ADVISORY
 BULLETIN

No. 2000-14
(Mercury Jet Drives No. 2000-02)

Hard Starting - 240 EFI M² Jet Drive

240 EFI M² Jet Drive

a - Disconnect TAN/BLACK Leads

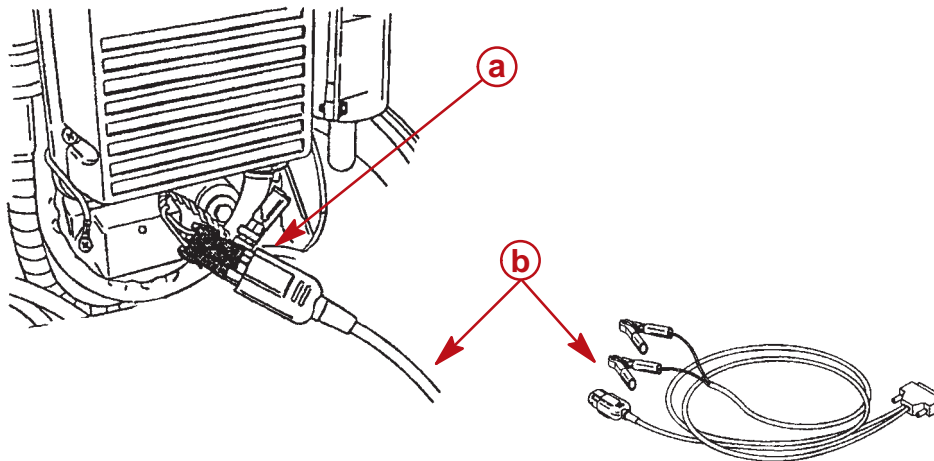
- Disconnect the TAN/BLACK lead wire from the temperature sensor and then start the engine. If this resolves the hard start condition, follow the corrective action described below.

a - ECM Diagnostic Port

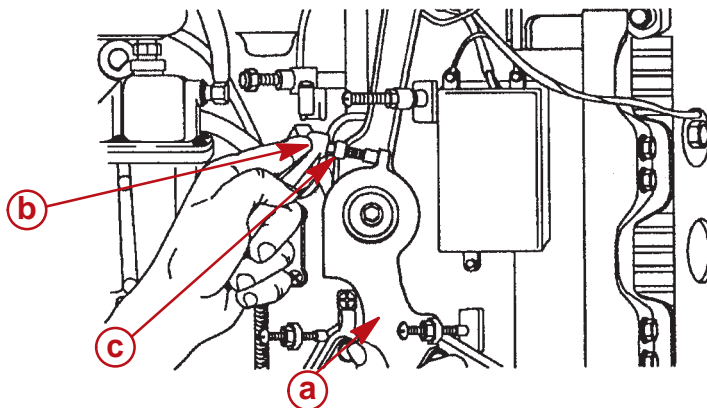
- Connect the DDT tester (91-823686A2) with cartridge (91-822608-6) to engine using the adapter cable (84-822560A5). Refer to DDT Tech manual (90-825159-2) for detailed instructions (p. 52).

- a - Throttle Arm
- b - Idle Timing Screw
- c - Locknut

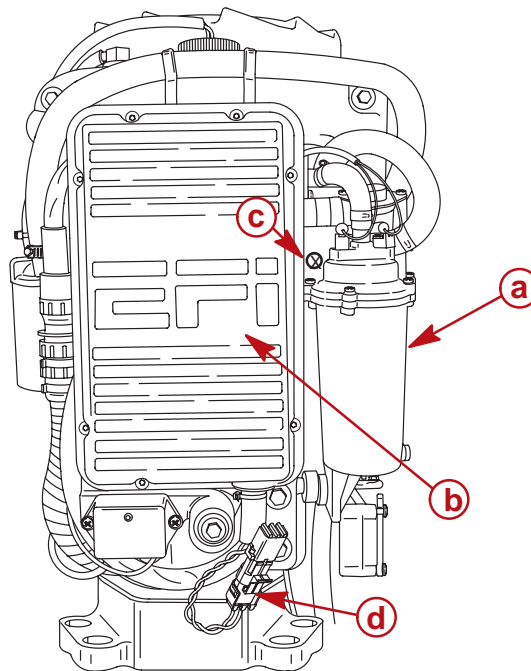
- With the DDT attached and engine idling: Hold throttle arm against idle stop (throttle cable barrel removed from barrel retainer). Adjust idle timing screw to 10 degrees BTDC. Tighten locknut.
